Regarding <https://www.kirklees.gov.uk/beta/planning-applications/search-for-planning-applications/detail.aspx?id=2021%2f93621>

1. Access and Transport links - Health and Safety
2. Suitability of the submitted plans
3. Queries on the Planning Application
4. Impact on existing properties
5. Conservation Area
6. General Observations

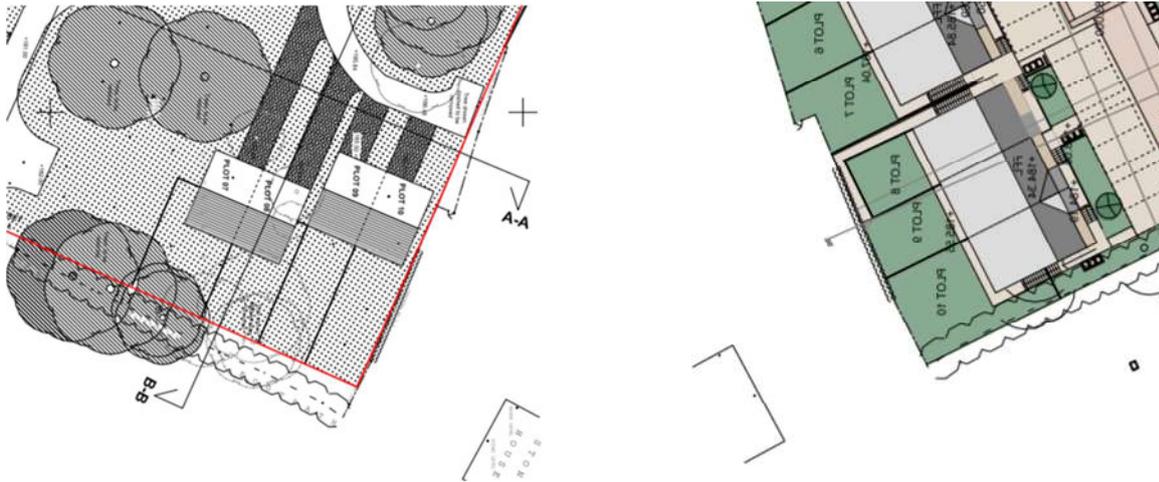
Speaking from our personal point of view in the previous plans the buildings were side on
https://www.kirklees.gov.uk/beta/planning-applications/search-for-planning-applications/filedownload.aspx?application_number=2017/93638&file_reference=675205 which would have had much less impact on the existing buildings in the area and make for a better integration of the new houses compared to the current submitted plans that have the rear of the buildings now facing our property (and significantly taller)

But even if they were further than 21m (which we strongly doubt) it will still be a huge impact and loss of privacy to have such large buildings overlooking existing properties because the plans are now “face to face” whereas before they weren't the proposals were for the new properties to be “side-on” hence mitigating the impact.

So if the houses could be reverted to the direction on the original plan (left image) and if Plots 9 & 10 could be located below Plots 7 & 8 then there would be no impact to the existing houses and no objections because they would be lower down the hill and not have an effect or be able to see into currently habitable rooms. Because as you can see from the right image which is the current application there is a significant impact on the current Listed Building sited within a Conservation Area.
